M E M O R A N D U M

SUBJECT: Ten Mile Creek Area Limited Amendment to the Clarksburg Master Plan and
Hyattstown Special Study Area

TO:	Brown and Caldwell / Biohabitats, a Joint Venture
CONTRACT NO.:	
SUBJECT:	Clarksburg Master Plan Limited Amendment for the Ten Mile Creek Watershed

Subject: Draft Response to September 9, 2013 Geosyntec Letter

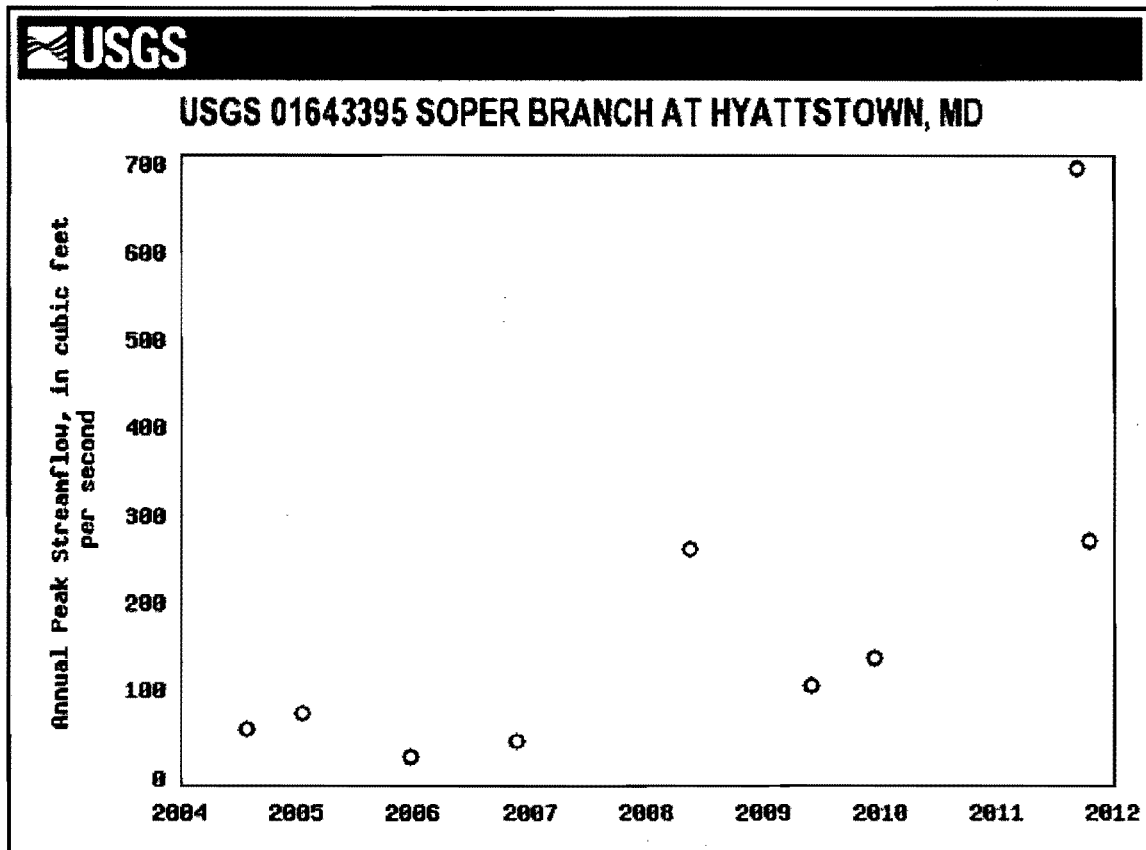
Geosyntec Comment: Existing conditions model results are well outside of independent predicted results and norms for the area....The MNCPPC's consultant's model appears to grossly underestimate peak flow rates in LSTM110 and LSTM111.

Response: We do not agree that the model grossly underestimated existing condition peak flow rates in LSTM110 and LSTM111.. Predicted peak flow rates are sensitive to various model algorithms and parameters, and can vary widely even within the range of accepted modeling methods and parameter values. The actual peak flow rates in LSTM110 and LSTM111 are unknown. Therefore, it is possible to arrive at different modeled predictions of peak flows under existing conditions. The Geosyntec comment letter cites three bases for comparison of predicted peak flows in LSTM110 and LSTM111:

1. USGS regression equations
2. Area-scaled continuous gage data from USGS gage 01644390—Ten Mile Creek Near Boyds, MD
3. Independent SWMM modeling

The USGS Regression Equation quoted by Geosyntec is several years old. USGS has updated the regressions and present data on the USGS stream statistics web site (http://streamstatsags.cr.usgs.gov/md_ss/default.aspx?stabbr=md&dt=130239302542270000). For a basin in the vicinity of the basins in question, this web site suggests a peak 2-yr flow of about 50 cfs for the 211-acre basin 110, which is greater than the value predicted by the Joint Venture but less than the value cited by Geosyntec. The Geosyntec model predicts peak 2-year flows twice the older USGS values and three times the more recent values.
